MFN 16-072

Response to Round 5 Requests for Additional Information 103 and 104,
65 (Revised), and 33 (Revised)

Non-Proprietary Information – Class I (Public)

Figure 7.1-1 Schematic Process for Combining Uncertainties

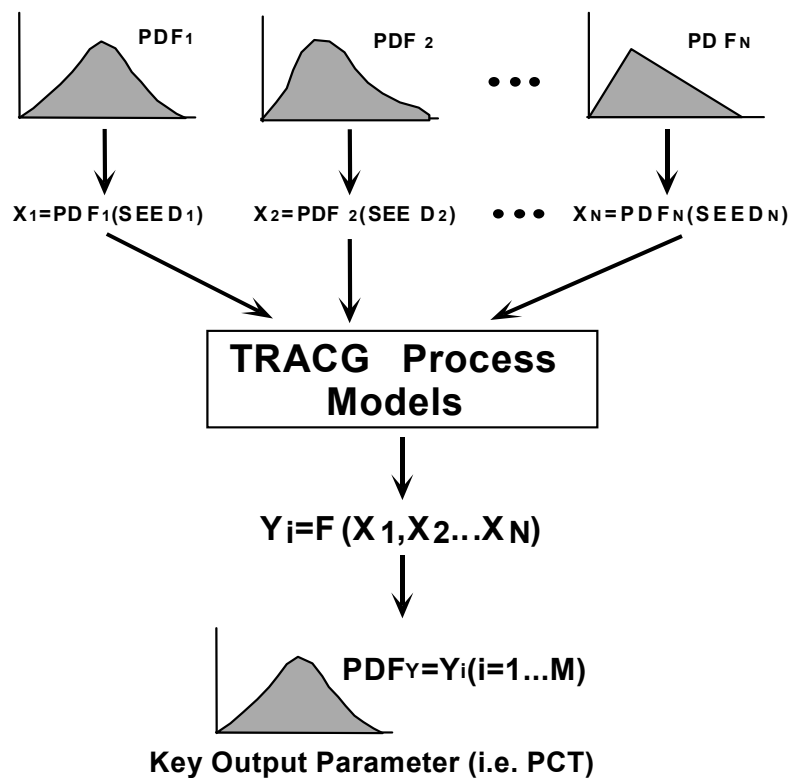
Section 7.1.1 of the TR states that continuity in the probability density functions for figures of merit is a requirement for determining non-parametric tolerance limits according to Wilks' Theorem. However, it is not obvious that these probability density functions will, in general, be continuous. In fact, [[]] calls the TR's assumption of continuity into question. Therefore, please demonstrate that the requirement for continuous probability density functions will be satisfied in the application of the evaluation model described in the TR for quantifying a single probabilistic statement of safety for the complete spectrum of break locations and sizes, the complete spectrum of model parameters and their variation, and the nonlinear feedback introduced by the engineered safety features. In other words, please show that there are no disjoint density functions of the figures of merit, or they can be identified and taken into account in the application of Wilks' Theorem.

parameters, the calculation process determines the output parameters of interest. In this manner, the effects of interactions between parameters are captured in a single calculation. Once all of the trials have been completed, the desired output parameter (e.g., PCT) is extracted from each of the trials and the set of all values of this parameter is used to construct its OSUTL. Figure 7.1-1 illustrates the process.

Figure 9.1-1 LOCA Analysis Process Flowchart

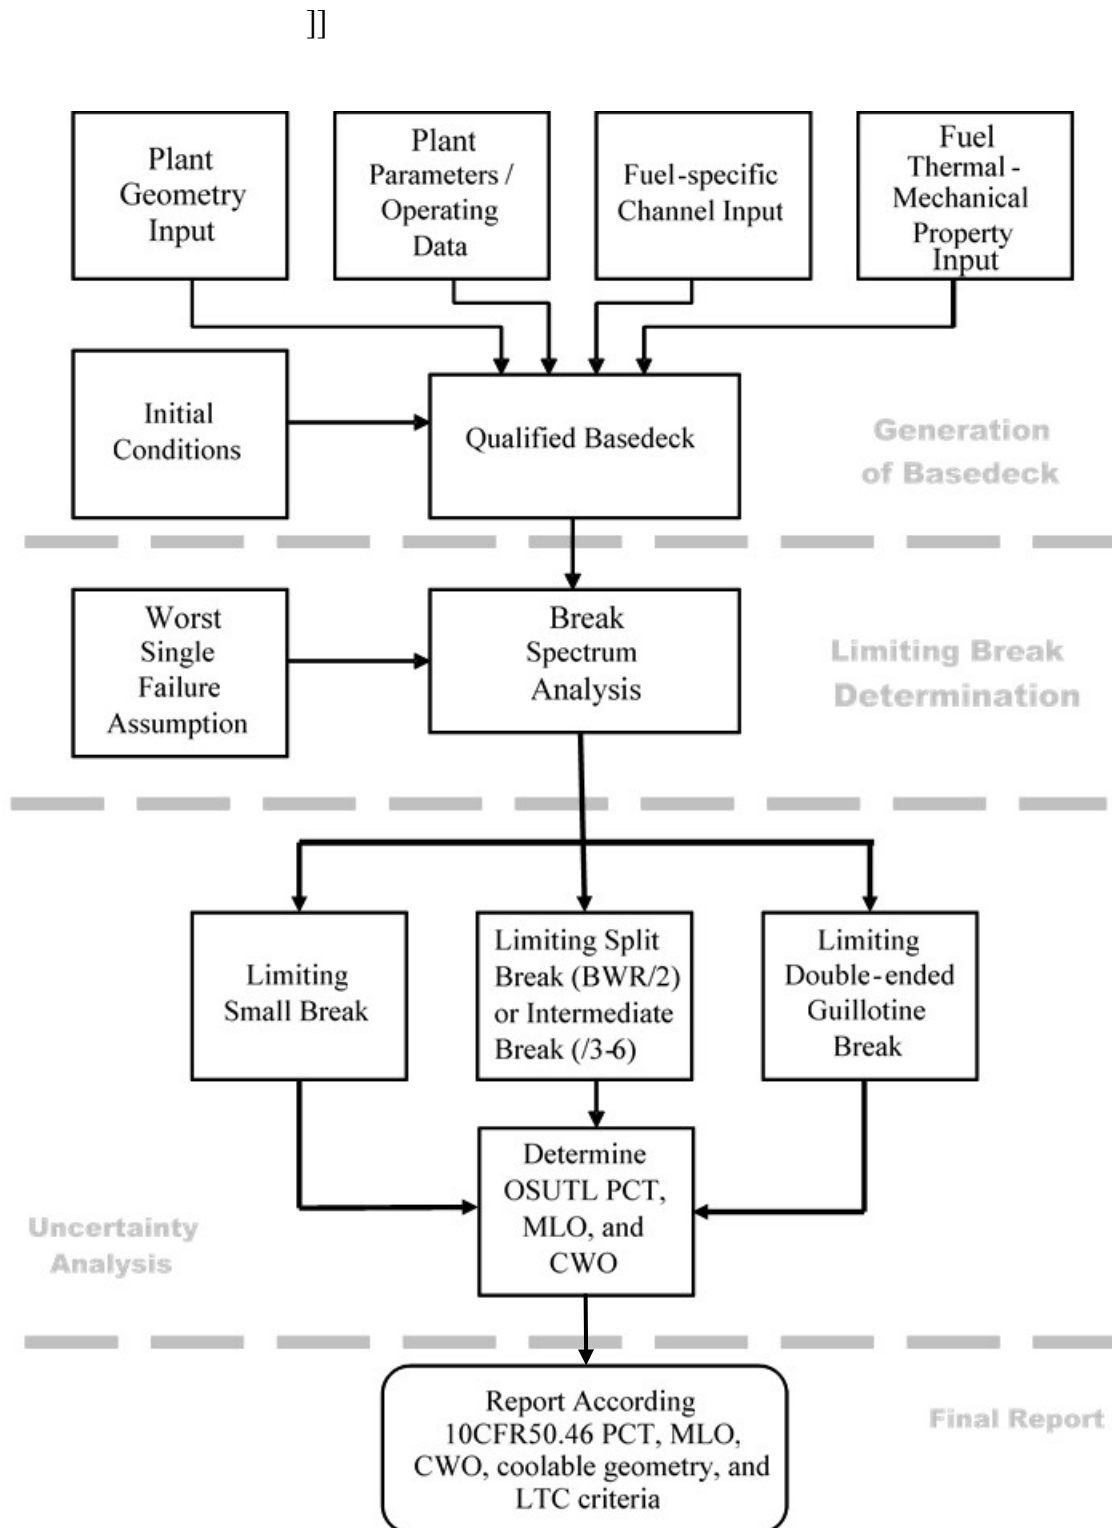
In response to prior RAIs 66 and 89, GEH provided justification for its proposed approach of analyzing uncertainty using at least three statistical samples, each containing 59 cases. The NRC staff does not accept the GEH justification that this approach provides the high-probability results required 10 CFR 50.46. In particular, because the method is used to determine high-probability results for three different critical safety parameters, an approach based on order statistics should identify an upper quantile, but should do so with high confidence. The high confidence is required so that the variability associated with using quasi-random samples to infer upper quantiles is either minimized or conservatively taken into account. Thus, in identifying a basis for a specified sample size, consideration of tri-variate coverage and the use of tolerance intervals are considered by the NRC staff to be acceptable approaches. Provide a statistical sampling basis that estimates an upper tolerance limit and provides tri-variate coverage. If the approach is proposed to allow other than the first-ranked order statistic as the upper tolerance limit, please also clearly delineate the approach for setting the sample size and number of rejected order statistics, providing information to demonstrate that sample sizes are set prior to initiation of production statistical analysis.

In this report, demonstration analyses are presented along with additional sensitivity studies that helped in making the methodology decisions. The demonstration cases are illustrative and do not represent any particular plant. Actual analysis of a given plant will employ plant-specific input modeling and plant-specific break spectrum calculation. The uncertainty analysis and post-processing of results are built on break spectrum studies. The overall analysis process can be depicted by the flowchart given in Figure 9.1-1.

Figure R104-1 Shumway Correlation versus his Stainless Steel Data {Fig. 1 in [R104- 2]}

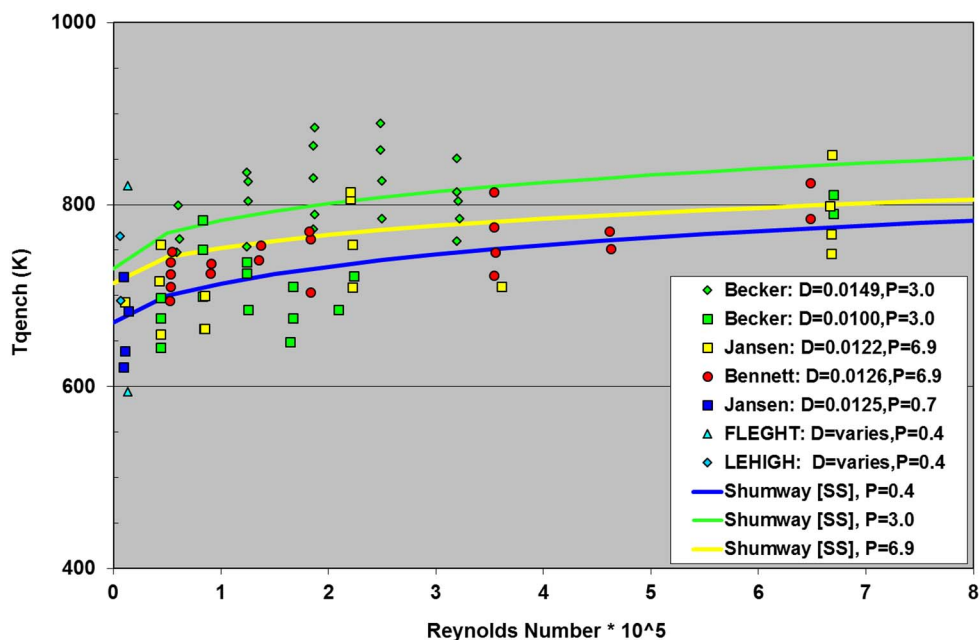
Provide additional information to justify the TRACG-LOCA modeling of rewet phenomena. In particular, show the sensitivity of the PCT and ECR to variations in the Shumway correlation-predicted rewet temperature and to variations in the uncertainty associated with the quench front model. Include discussion of limiting BWR transients as well as to appropriate integral effects test.

Shumway's correlation was established exclusively from stainless steel (SS) data over a relative wide range of pressures and flow rates as shown Figure R104-1. The GEH evaluation of the correlation compared to its own SS data is that on average it conservatively overestimates the 81 useable data points by 23 K with a standard deviation of 55 K when evaluated at $\alpha=1$. Most of the overestimation is at the higher pressures. For pressure at and below 0.7 MPa that are most relevant for LOCA applications, the bias is -1.2 K. As explained in RAI-50, a 20% uncertainty applied to the calculated difference ($T_{min}-T_{sat}$) sufficiently covers the 55 K standard deviation. In TRACG LOCA applications no credit is taken for the slight conservative bias at low pressure since this bias is not considered in the BEPU sampling. More important is the fact that the Shumway evaluation of ($T_{min}-T_{sat}$) as implemented in TRACG is even more conservatively biased for Zircaloy and this bias is not credited.
